PARTS & SERVICE NEWS

REF NO.	AA97003A
DATE	Feb. 15, 1999

SUBJECT: REPLACEMENT PARTS FOR DRIVE SHAFTS

PURPOSE: To provide kits and service parts lists for drive shafts and make available a greasable cross and bearing kit for the below listed graders.

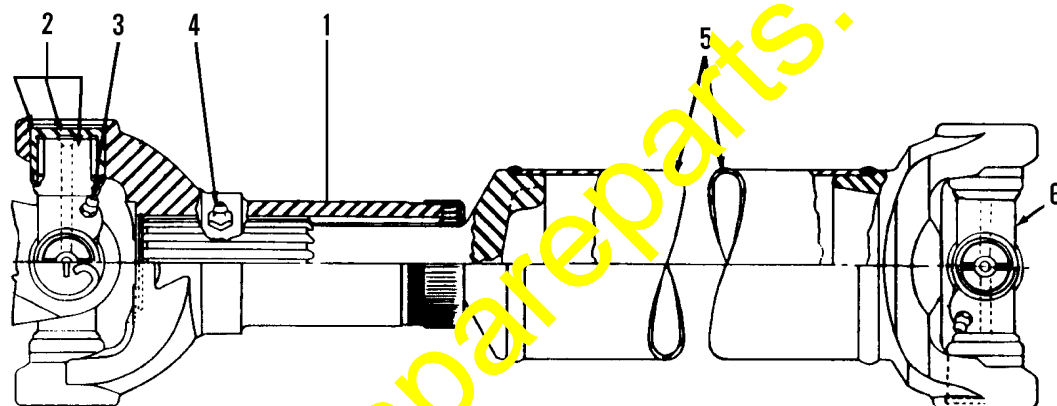
The spider and bearing parts for the drive shaft are no longer available separately. They have been combined in a service kit.

The greasable style cross and bearing kit is now an upgrade item for all grader applications when looseness or problems are noticed in either joint. The replacement cross and bearing kit should be greased every 250 hours with Komatsu Super grease or equivalent. Both cross and bearing kits on a drive shaft should be of the same style.
